Regarding: 08V-180

Technical BULLETIN

2006~2007 CP250 (Morphous); 2005~2007 YP400 (Majesty) FACTORY MODIFICATION CAMPAIGN – Fuel Pump Harness

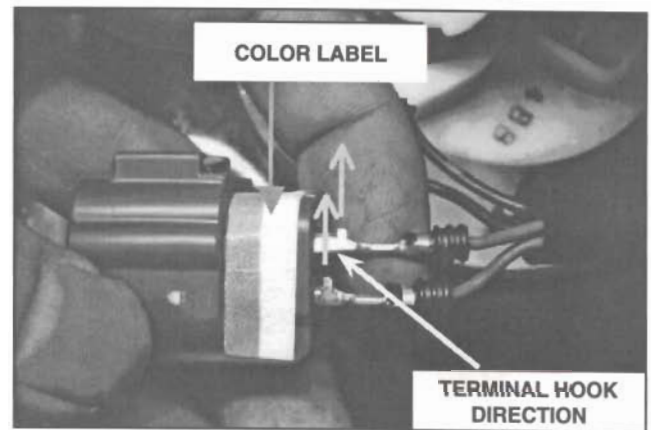
4. Install the wire terminals into the new coupler in the position described below. Make sure to push the terminal into the terminal slot all the way until it clicks. If the terminal is inserted in the wrong direction, it cannot be inserted all the way. Reinstall the inner cover.

5. Install the fuel pump sub-harness. Plug one end of the fuel pump sub-harness into the coupler modified in step 4 above and the other into the fuel pump.

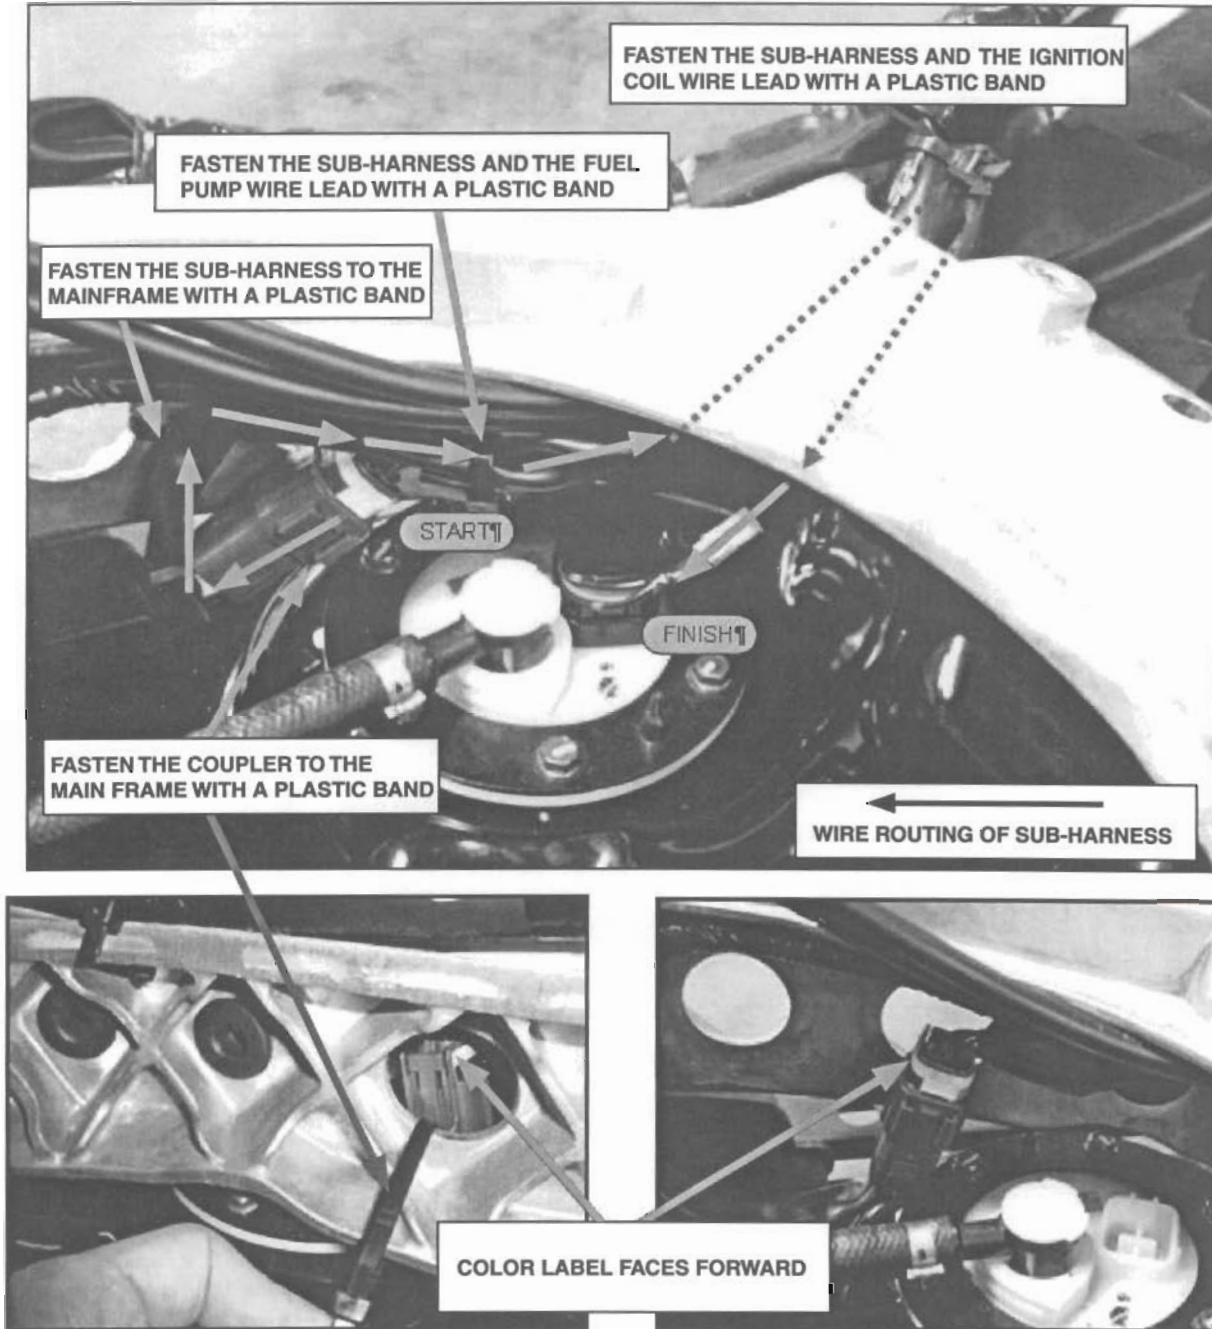
6. Secure the fuel pump sub-harness with the supplied plastic bands (zip ties) as shown.

Be sure to secure the fuel pump sub-harness as shown. This positions the wire harness coupler of the main wire harness in a position that will allow any water that enters the wire harness to drain out.

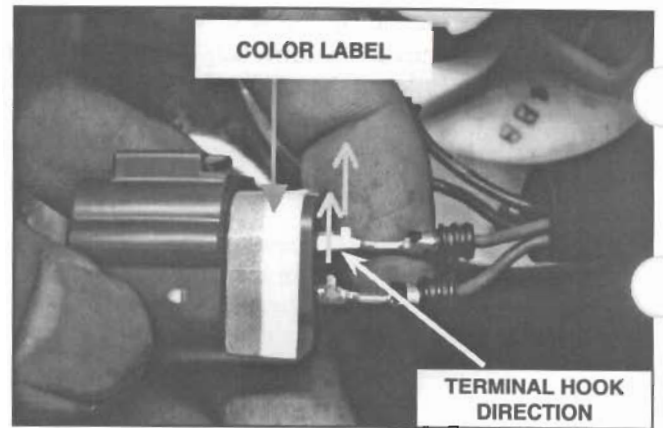
8. Install the wire terminals into the new coupler in the position described below. Make sure to push the terminal into the terminal slot all the way until it clicks. If the terminal is inserted in the wrong direction, it cannot be inserted all the way. Reinstall the inner cover.

9. Install the fuel pump sub-harness. Plug one end of the fuel pump subharness into the coupler modified in step 8 above and the other into the fuel pump.

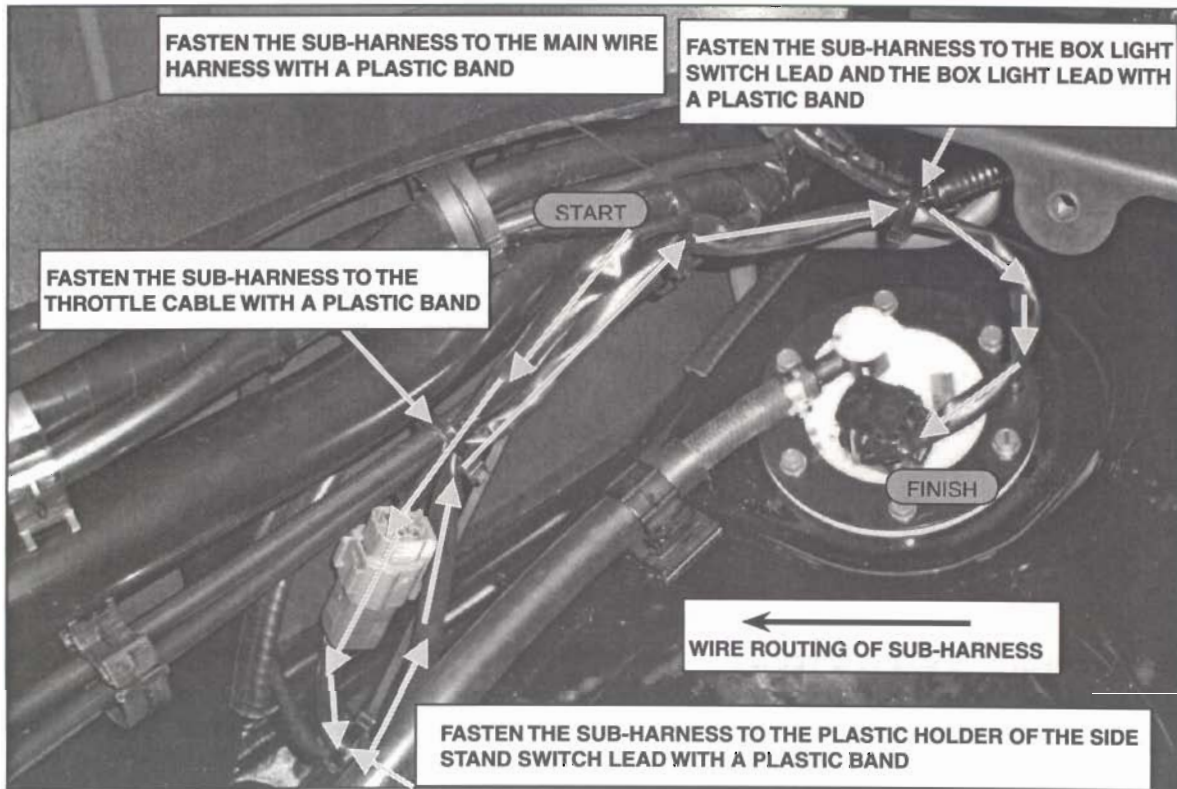
10. Secure the fuel pump sub-harness with the supplied plastic bands (zip ties) as shown.

Be sure to secure the fuel pump sub-harness as shown below. This positions the wire harness coupler of the main wire harness in a position that will allow any water that enters the wire harness to drain.
